P: | WP | UFM |

## USE OF ULTRASONIC FLOW MEASUREMENT TO DETERMINE REACTOR POWER

Presentation Date: June 8, 2006

# Ultrasonic Flow Meter Comparison

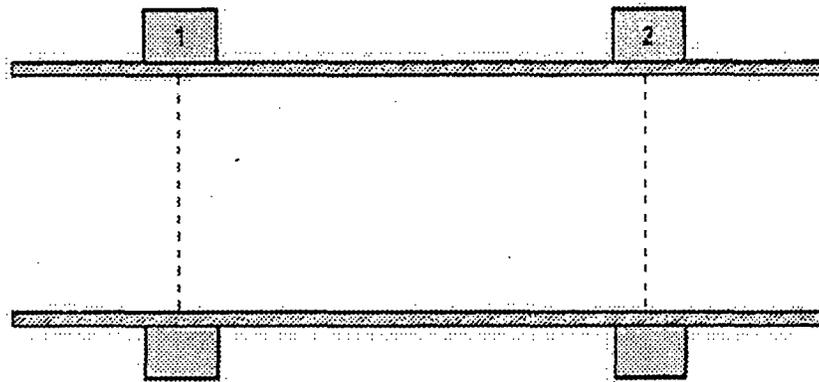
- ✓ Caldon Check and Checkplus meet all criteria
- ✓ W/AMAG Crossflow has not been shown to meet criteria, but staff has not completed review of all submitted information
